OICA Statements for PMP IWG Meeting Sep. 22, 2022

Version 22.09.2022

OUTLINE

Influence of cooling air temperature (23°C vs. 20°C) in WLTP Brake Emission Procedure

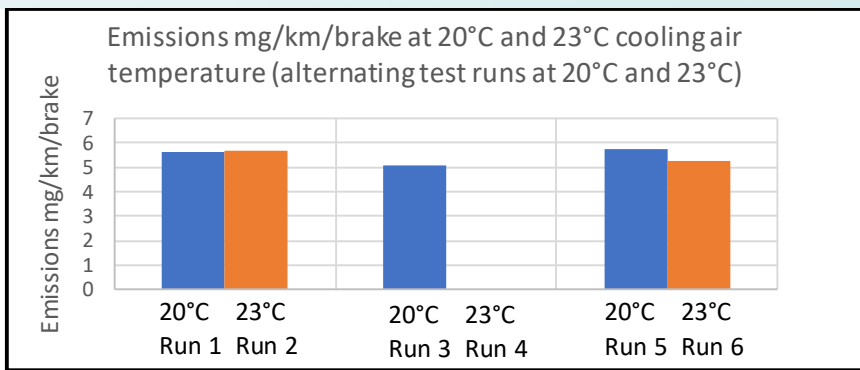
- OICA requests to change the cooling air temperature from 20°C to 23°C – in-line with WLTP exhaust testing
- Brake temperature and emission data show no impact

The increase of cooling air temperature from 20 to 23°C generated neglectable disc temperature difference during the tests (less 2°C on average).

This temperature difference did not generate any noticeable differences in the PM10 emissions.

ENCLOSURE PROPOSAL

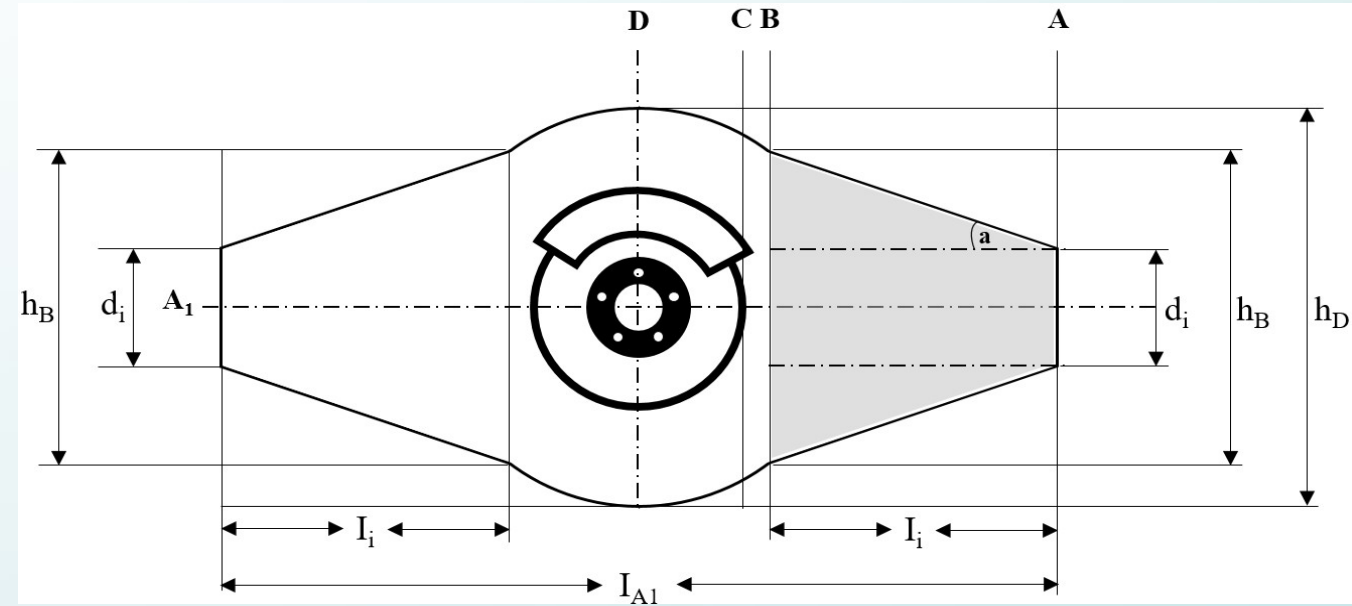
In order to reduce particle losses and lab-to-lab variability, the enclosure design parameters need to be tightened

Symbol	Description	Draft GTR	Prelim recommendation tbc.
d_i	Inlet & outlet \emptyset	175 to 225mm	200mm \pm 5mm & 203.2mm \pm 5mm (8" duct)
h_B	Length of plane B (enclosure)		600mm
h_D	Length of plane D (enclosure)	600 to 750mm	600mm
a	Transition angle	15° to 30°	tbd
h_B / h_D	Ratio of heights plane B – plane D	> 60%	100%
	Radius of largest disc (dist. planes B & C)		225mm
	Cross section depth at plane B	= h_B	500mm (alt. 600mm)
	Max. axial depth at plane D	400 to 500mm	500mm (alt. 600mm)
I_{A1}	Length of plane A1 (enclosure)	1200 to 1400mm	1400mm (alt. 1600mm)

ENCLOSURE PROPOSAL

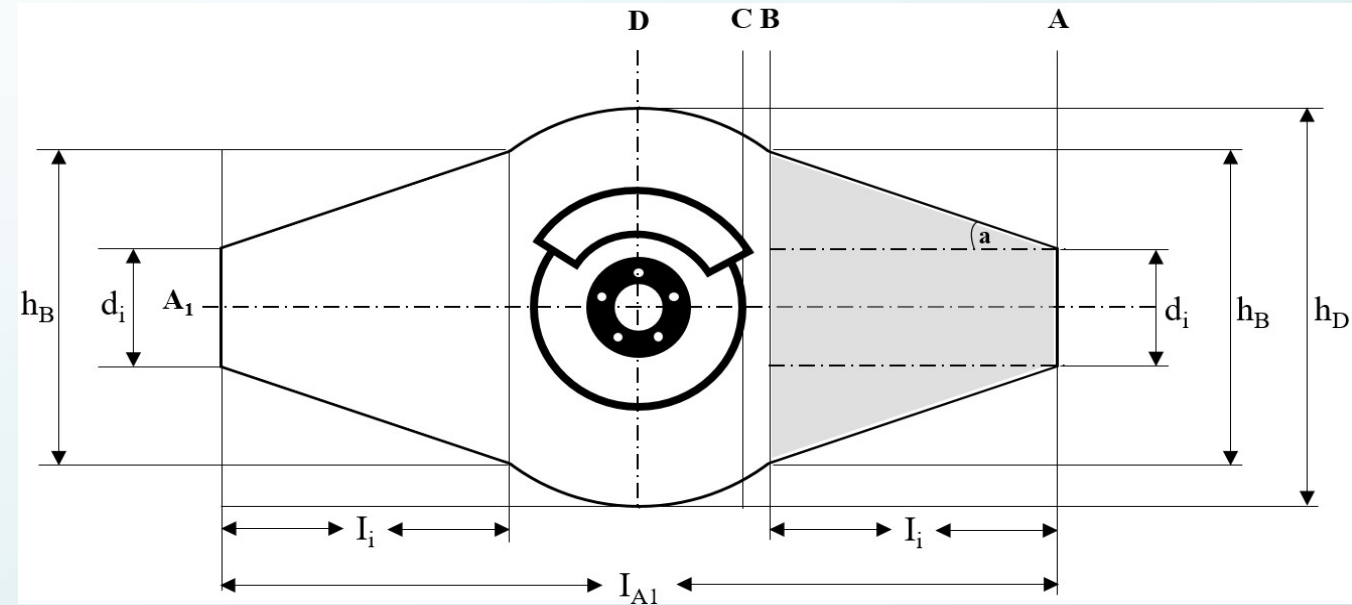
Symbol	Description	Draft GTR	Prelim recommendation tbc.
L5	Min length to next disturbance & downstream of airflow measurement element		2*di tbd (400mm?)
r _B	Bending radius of the cooling air duct		3*di tbd
R1	Radius of bend downstream of sampling plane (or upstream of sampling plane in a different layout)		tbd
	Where noted above and several other parameters remain work in progress		tbd

Table 1 – Default temperature metrics and limits for brakes during Trip #10 of the WLTP-Brake Cycle

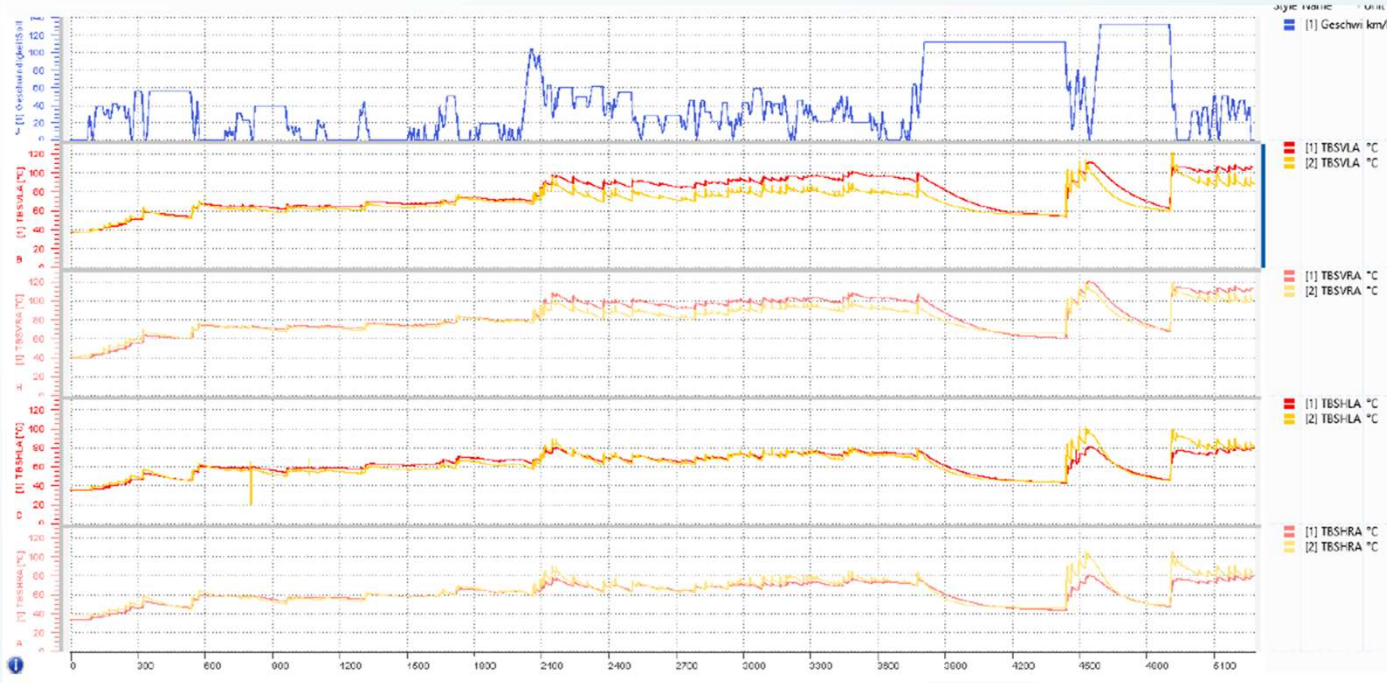
- WLTP-Brake temperature ranges are determined by the WL/DM ratio
- However, disc mass (DM) considers only gray cast iron (GJL) rotors
- **Lightweight materials / rotor concepts are not taken into account**

- If, for the same vehicle, a GJL rotor would be categorized in group <45, the respective ceramic rotor (CSiC), with equal or even larger dimensions, would be “catapulted” in group >85
- Unrealistic group classification if specific heat capacity is not considered.

1. Innovative lightweight-brake rotors (ex. CSiC ceramic rotors) would be penalized through disproportionately high temperatures
2. The required high IBT & FBT classes in combination with large ceramic rotors, imply reduced cooling air flows which could impact the PM measuring ability

- * Standardized-factors shall be elaborated for relevant brake rotor materials (ex. S CSiC = 1,7)
- * Factors should be introduced in the GTR for non-gray cast iron friction rings (non-GJL)
- * No cp-measurement at local brake test facilities / laboratories needed

Proposal B: Note the possibility to use real vehicle temperature data to find the right WL/DM class **for non-gray cast iron friction rings (non-GJL)** in the GTR

MULTIPLE SAMPLING

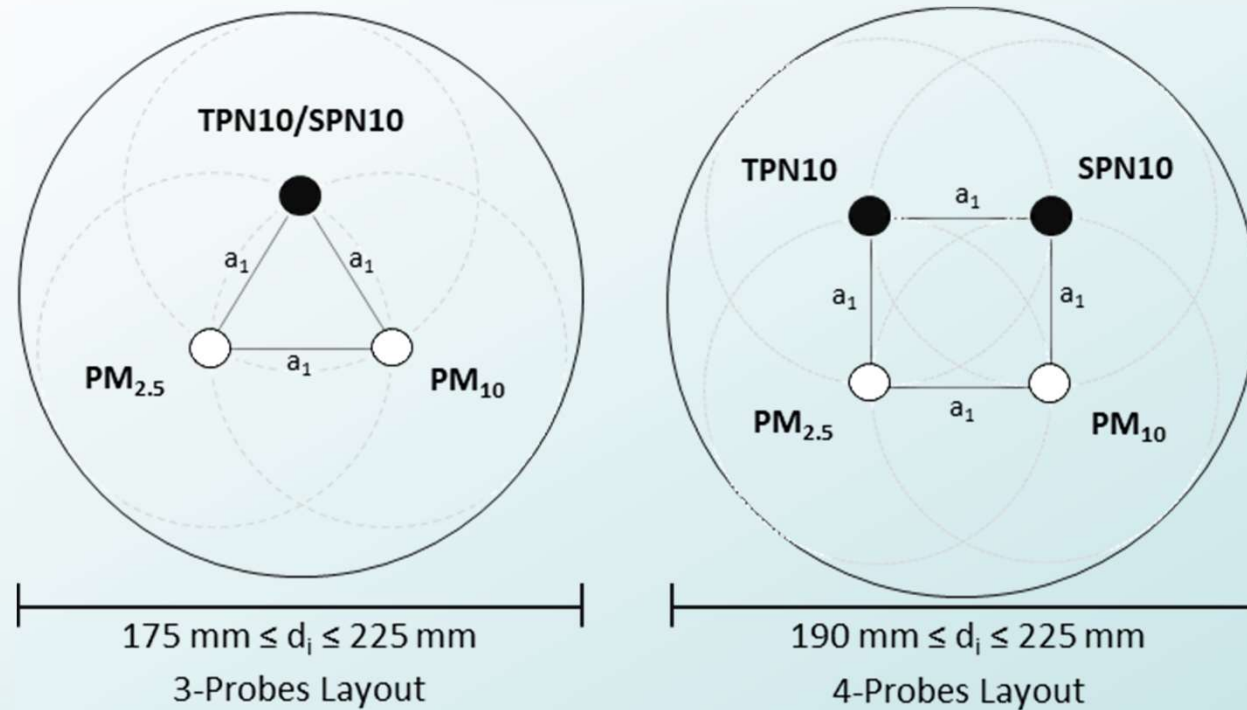
- Investigations show that stability of brake systems can only be determined by multiple, consecutive measurements.
- OICA therefore proposes the usage of multi-sampling systems (e.g. 3 filters) to enable automated testing with one brake system test setup.
- Due to the lack of very volatile particles the handling and storage of the filters etc. should be of minor concern.
- To OICA's understanding, investigations on influence of losses on such systems are in progress
- To OICA's understanding, enhanced instruments with little effect on flow, losses etc. are in development

QUESTION FOR CLARIFICATION ON SEPARATE PM10 and PM2.5 SAMPLING PROBES

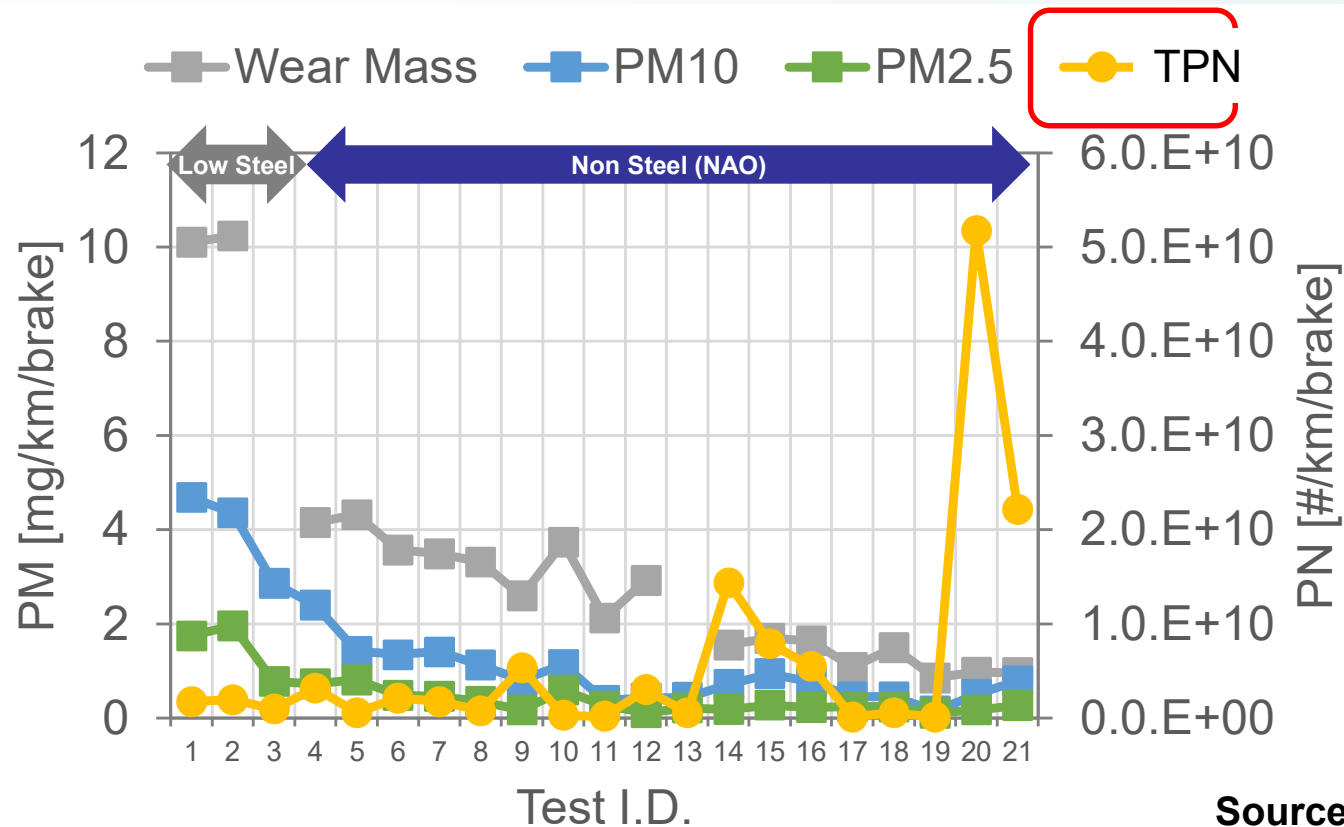
In PM measurements, PM_{2.5} and PM₁₀ are to be measured separately with separate probes without using cascade impactors.

PM₁₀ includes PM_{2.5}, and there is no necessity to measure PM₁₀ and PM_{2.5} using separate probes.

We would like to know the reason for this method.

CONCERNS REGARDING PN

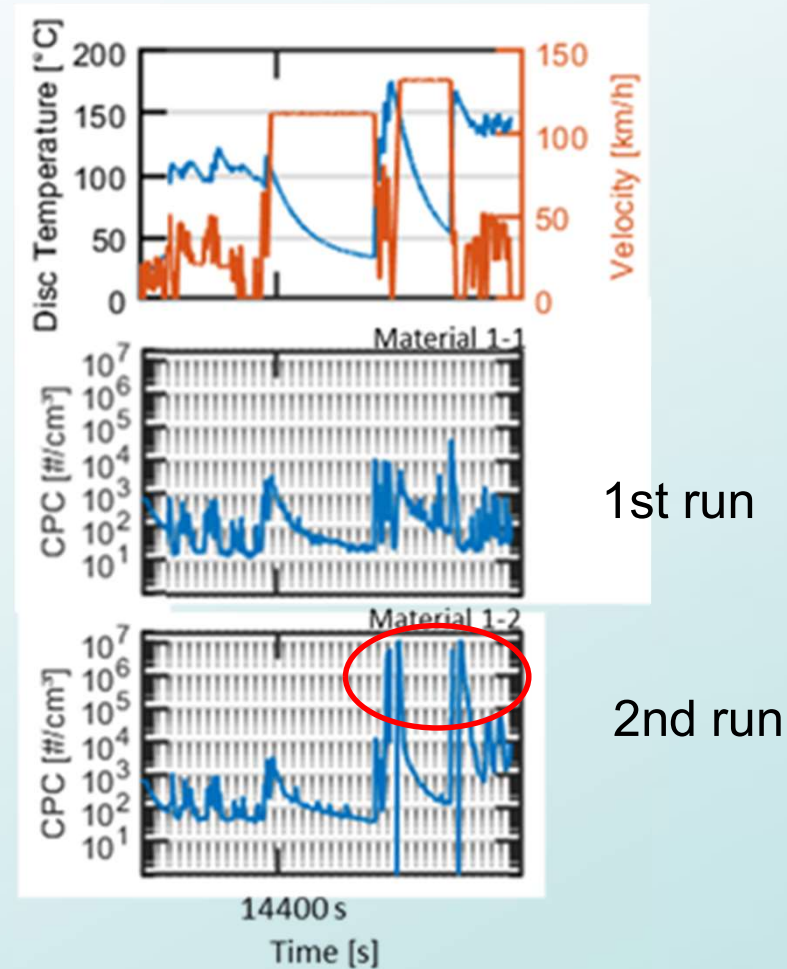
- The measurement of PN is complex and results are not consistent

- Two subsequent measurements of TPN with the same brake disc / pad have substantially different TPN results

- In contrast to the SPN** (Solid Particle number) TPN* is a newly introduced variable for which there is no established measurement and calibration procedure today. The draft GTR description for the TPN-measurement setup allows for major differences. Anything is permitted, from a setup with only one dilution stage with a dilution Rate of 1:10 up to a two dilution stage VPR-setup used in the exhaust gas measurement area (not actively heated) with dilution rate of 1:100 and higher.
- The PCRF calibration is not able to correct large differences that result from significantly different measurement setups and conditions.
- The consequence is that TPN measurement results from different brake wear particle test benches for the same brake differ significantly and cannot be reproduced.
